**100-NR-1 Operable Unit Treatment, Storage, and Disposal
Interim Action Record of Decision**

**100-NR-1/100-NR-2 Operable Unit Interim Action Record of
Decision**

**Hanford Site – 100 Area (100-N)
Benton County, Washington**

**Explanation of Significant Difference
May 2003**

Figure 1. 100-NR-1 Operable Unit.

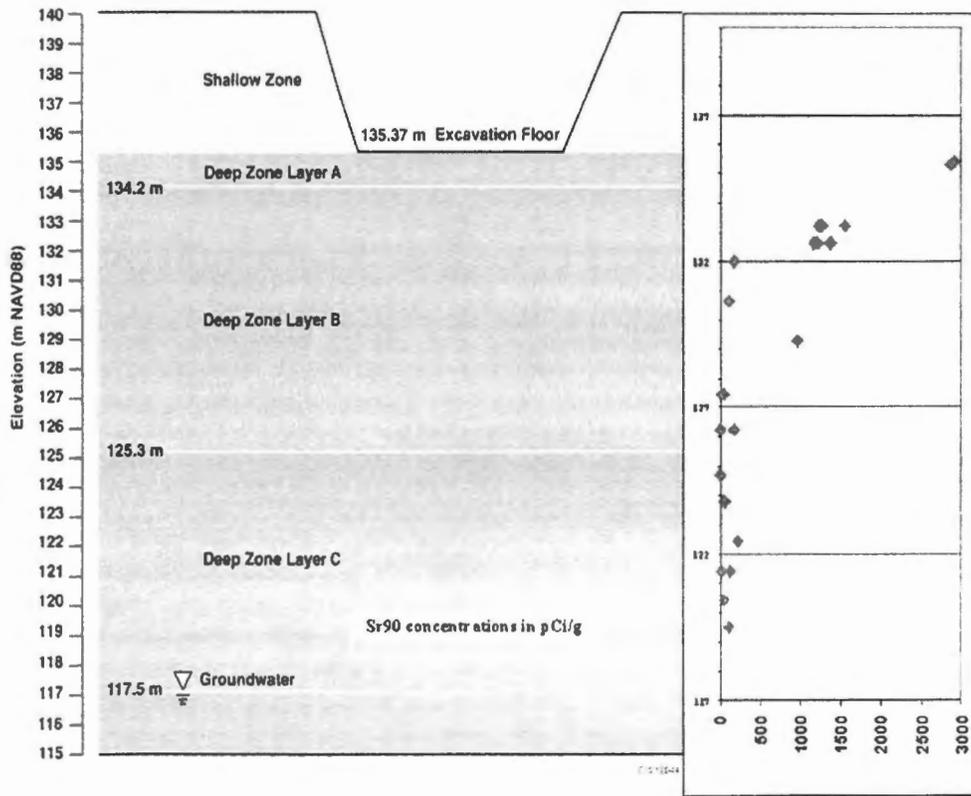
The TSD ROD addresses contaminated soils, structures, and pipelines associated with two TSD units in the 100-NR-1 OU: the 116-N-1 and 116-N-3 waste sites (Figure 1). The 100-NR-1/100-NR-2 ROD addresses all of the other remaining soil waste sites in the 100-NR-1 OU, as well as the 100-NR-2 groundwater OU. EPA, Ecology, and DOE approved the TSD ROD in January 2000, and the 100-NR-1/100-NR-2 ROD was approved in December 1999.

The 116-N-1 and 116-N-3 waste sites received radioactive liquid waste containing activation and fission products, as well as small quantities of corrosive liquids and laboratory chemicals generated by various N Reactor operations (Figure 1). The 116-N-1 waste site, which was in operation from 1963 to 1985, is 88 m (290 ft) long by 38 m (125 ft) wide by 1.5 m (5 ft) deep. The contaminants of concern in the surface soils were derived from data in the *100-NR-1 Treatment, Storage, and Disposal Units Corrective Measures Study/Closure Plan*. The radionuclides of concern include cesium-137, cobalt-60, europium-154, europium-155, plutonium-239/240, strontium-90, and tritium. The 116-N-1 waste site is actively undergoing remediation, which began in October 2001. Contaminated soil in the top 4.6 m (15 ft) is being removed and disposed as required by the TSD ROD. This represents a significant mass of the contamination, as nearly 130,000 tons of contaminated soil have been removed and disposed to date, with an additional 120,000 tons of contaminated soil removal expected over the next 18 months. This contamination removal in the top 4.6 m (15 ft) represents approximately 3,283 Ci. This action complies with the TSD ROD requirement for removing the contamination in the top 4.6 m (15 ft) below surrounding grade or the bottom of the engineered structure, which contains a significant inventory.

Table A-1. Assumption Summary: Excavation to Groundwater (Conventional).^a

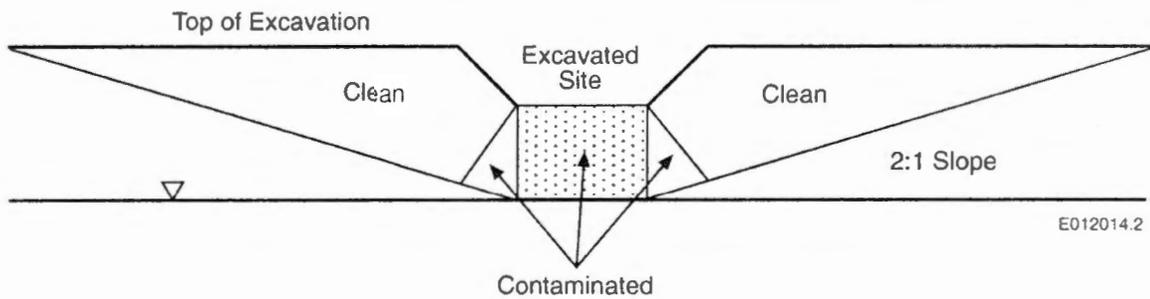
Item	Assumption
Excavate and stockpile clean overburden, then return to excavation	Assumes 2:1 slope.
Excavate and stage for transport contaminated soil	Assumes that entire footprint and additional 30% of soil beyond excavation footprint is contaminated.
Transport and disposal of contaminated soil in the ERDF	Assumes 458,562 additional tons transported and disposed and construction of ERDF capacity.
Backfill from onsite borrow pit	Assumes borrow pit less than 6 km from waste site.
Project support	Includes radiation control technician, health and safety, field oversight, engineering and environmental, waste management, and sampling and analytical costs for the 32-month duration.

^a Assumes traditional excavation methods currently used. Generalized conceptual excavation cross section shown below.

Table A-2. Assumption Summary: Soil Removal by Augering to Groundwater.^a

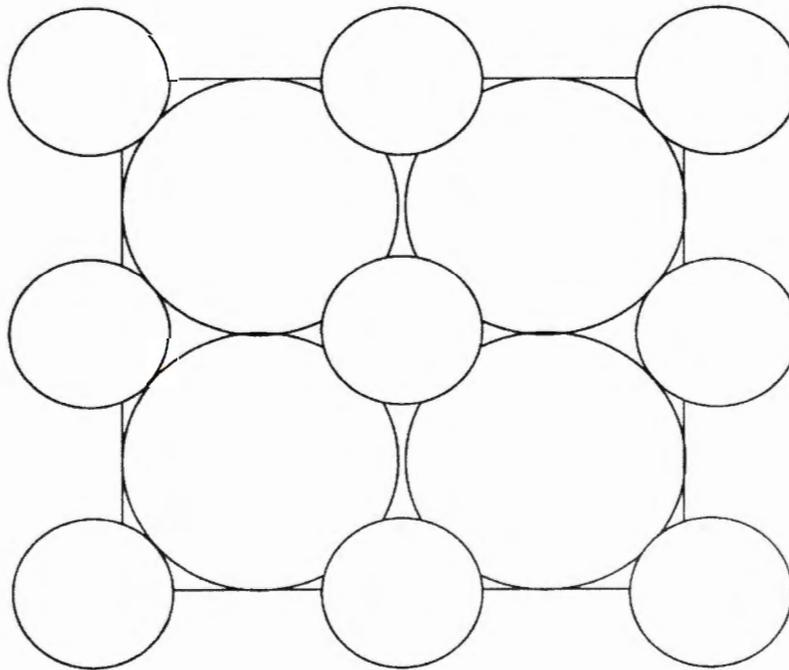
Item	Assumption
Augering	Assumes 2-m-diameter holes with 1-m-diameter holes in between. This equates to approximately 2,283 holes (2 m each), and 2,553 holes (1 m each) over the entire excavation footprint.
Grouting	Grout displaces soil in the holes. Assumes a batch plant is set up onsite.
Transport and disposal of contaminated soil in the ERDF	Assumes 349,007 additional tons transported and disposed and construction of ERDF capacity.
Project support	Includes radiation control technician, health and safety, field oversight, engineering and environmental, waste management, and sampling and analytical costs for the 62-month duration.

^a Four large bore (2-m) machines used in this estimate. Only 98% of the contaminated soil will be removed due to the circular nature of holes. Basic layout pattern is shown below.

Table A-3. Assumption Summary: Subsurface Barrier.^a

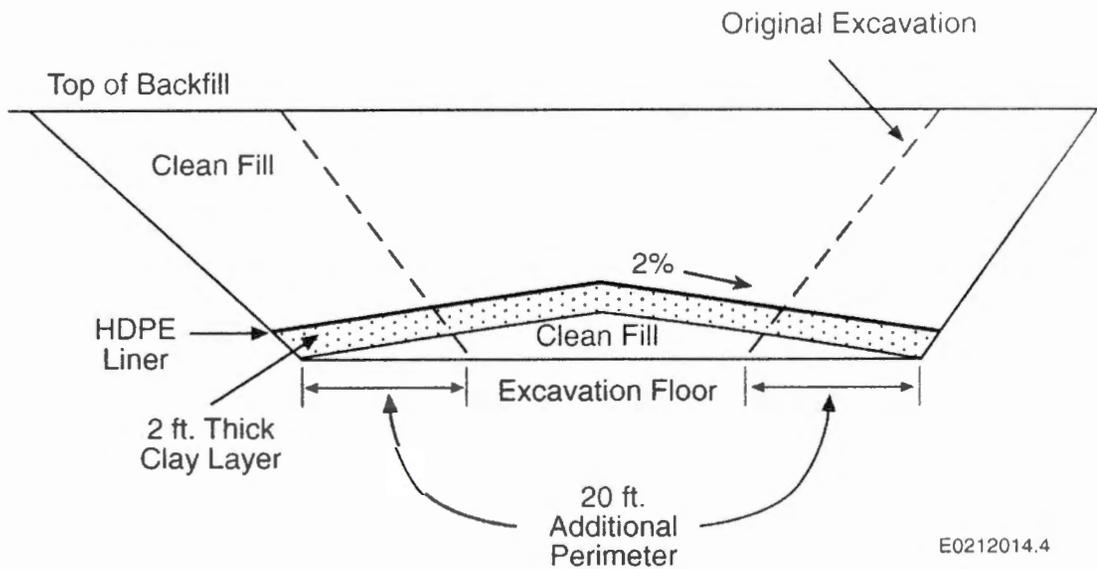
Item	Assumption
Excavate and stockpile clean overburden, then return to excavation	Assumes 1.5:1 slope, removal of additional 20-ft perimeter around entire waste site to reduce lateral infiltration.
Excavate, transport, and disposal of contaminated soil in the ERDF	Assumes 6,392 additional tons of contaminated soil transported and disposed and construction of ERDF capacity.
Backfill lowest layer from onsite borrow pit	Assumes borrow pit less than 6 km from waste site.
Install 2-ft clay liner excavation	<i>RS Means Environmental Cost Data.</i>
Install 80-mil HDPE geotextile liner above clay layer	<i>RS Means Environmental Cost Data.</i>
Project support	Includes radiation control technician, health and safety, field oversight, engineering and environmental, waste management, and sampling and analytical costs for the 12-month duration.

^a Generalized conceptual cross section shown below.
